DETAILED ASSESSMENT REPORT

APPLICATION FOR DEVELOPMENT APPROVAL

The application seeks approval for a Development Permit for Material Change of Use of Premises to Establish a Funeral Parlour and Function Facility.

Figure 6 – SPP Bushfire Hazard Mapping

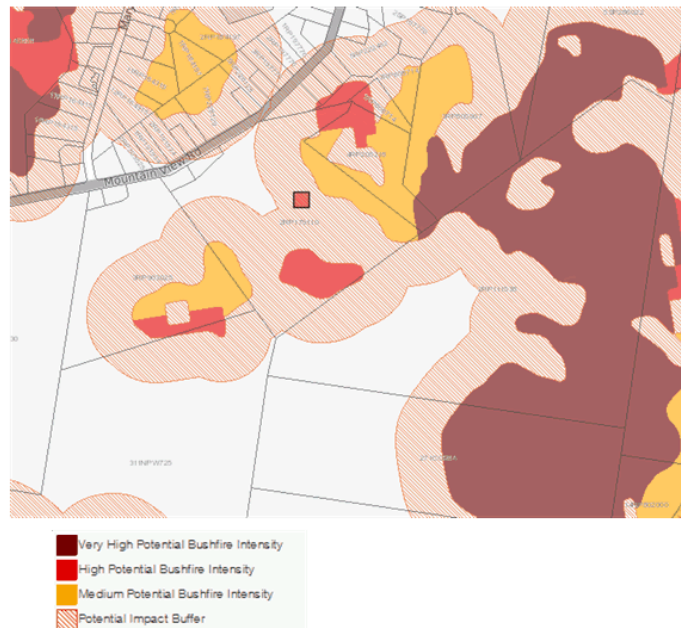
The site is identified to contain High and Medium Potential Bushfire Intensity Areas and associated buffers identified by the State Planning Policy mapping as illustrated in Figure 6 below. The hazard areas identified in the State Planning Policy mapping are more extensive than those identified by the *Sunshine Coast Planning Scheme 2014* and therefore the application is required to be assessed against the State Planning Policy.

The applicant submitted a Bushfire Management Plan, prepared by Duke Environmental, to assess the bushfire risk to the proposed development. The report had regard to the SPP – Part E, *the Bushfire hazard overlay code*, the planning schemes *Bushfire hazard overlay code* the Australian Standard – Construction in Bushfire Prone Areas (AS3959-2009).

The report concluded that there is a Medium Potential Bushfire Hazard affecting the site from the south and east. The report made a number of recommendations that it considers would substantially mitigate the bushfire hazard acting on the proposed development which are summarised as follows:

- Establishing and maintaining an Asset Protection Zones (APZ) between the building and the hazardous vegetation to reduce fuel loads;
- Constructing the buildings in accordance with Bushfire Attack Level (BAL) as per Australian Standard AS3959 -2009 (FDI50 and vegetation classification "forest") to minimise potential impacts;
- Any landscaping is not to include plantings of Eucalypt and other flammable species. Plantings should generally involve local species with low fire risk;
- Garden mulch applied in landscaped areas is to incorporate non-flammable material such as pebbles or stone. Flammable mulch such as pine mulch or forest mulch is not be used, particularly within 5m of any structure.

The application was referred to council's Ecology Specialist who advised that the submitted bushfire report satisfactorily addresses the relevant requirements. It was advised that the recommendations of the report should be adopted and the report should

become a referenced document. Reasonable and relevant bushfire management conditions are recommended.
